UNITED STATES PATENT AND TRADEMARK OFFICE

APPLICATION NO.	FILING DATE	FIRST NAMED INVENTOR	ATTORNEY DOCKET NO.	CONFIRMATION NO.
09/683,482	01/07/2002	Jia-Fan Wong	ADTP0028USA	2814

Office Action Summary

DETAILED ACTION

FIG. 9

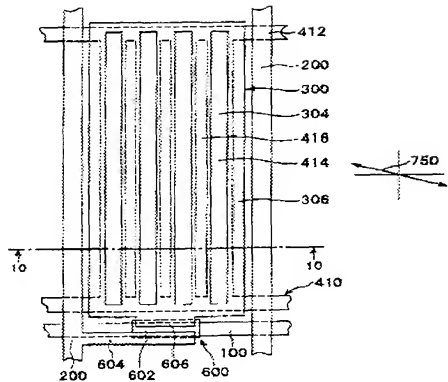
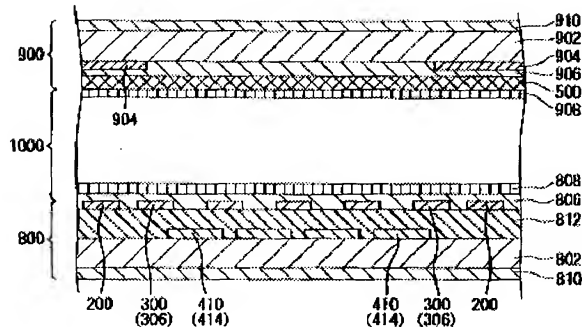
As to claims 1, 3 and 4, Matsuyama discloses in Figures 9 and 10, third embodiment (col. 21, line 36 through col. 22, line 55), a liquid crystal display (LCD) comprising: a first substrate, 900, comprising a first surface; a second substrate, 800, comprising a second surface, the second surface being in parallel with and opposite to the first surface of the first substrate, and a pixel area being defined on the second surface; a second common electrode, 500 (Applicant's first electrode), positioned on the first surface of the first substrate; a first common electrode, 410 (Applicant's second electrode), disposed above the pixel region of the second substrate, the second electrode having side opening portions, 416 (Applicant's first slit) elongated along a first

direction; an isolation layer, 812, disposed on the surface of the second substrate to cover the second electrode; a pixel electrode, 300 (Applicant's third electrode), disposed on the isolation layer and within the pixel region, opening portions, 304 (Applicant's second slit), being defined on the third electrode and along the first direction, the first and second slits being interlaced (per Figures 9 and 10); and a plurality of anisotropic liquid crystal molecules with negative dielectric constant (Abstract) positioned between the first electrode and the third electrode, the longitudinal axis of the liquid crystal molecules being positioned along a second direction horizontally (Figure 3 and col. 21, lines 42-45), and a first angle being formed between the first direction and the second direction; wherein a biased electric field is formed as a voltage is applied between the first electrode and the second electrode, such that (a) a first horizontal biased electric field is formed in the neighborhood of the second slit (Figure 4), the first horizontal biased electric field is perpendicular to the first direction, and the liquid crystal molecules are rotated to make the longitudinal axis of the liquid crystal molecules in the neighborhood of the second slit being in parallel to the first direction, (b) the longitudinal axis of the liquid crystal molecules in the neighborhood of the first electrode maintain along the second direction because no horizontal biased electrical field is formed near the first electrode, and (c) the liquid crystal molecules between the first electrode and the second slit of the third electrode gradually rotate from the second direction to the first direction,

wherein the second electrode, 410, is a transparent common electrode (Applicant's pixel electrode) (col. 15, lines 14-17 and col. 21, lines 42-45) and wherein the third electrode, 300, is a transparent pixel electrode (Applicant's second common electrode).

However, Matsuyama does not explicitly disclose a display wherein the second electrode, 410, is a pixel electrode and wherein the third electrode, 300, is a lower common electrode.

Sato teaches in his first embodiment (Figures 7 and 8) a TFT substrate that has the pixel electrode above the common electrode with a bottom gate TFT (col. 8, lines 63-65) is functionally equivalent (col. 12, lines 7-11) to his second embodiment (Figures 10 and 11) a TFT substrate that has the common electrode above the pixel electrode with a top gate TFT (col. 11, lines 59-61). Furthermore, reversal of parts is considered an obvious expedient, MPEP 2144.04, VI, A.

As to claim 9, Matsuyama discloses a display wherein the third electrode has a width, and the width is reduced by opening portions, 304 (Applicant's second slit), so as to increase an aperture ratio of the display.
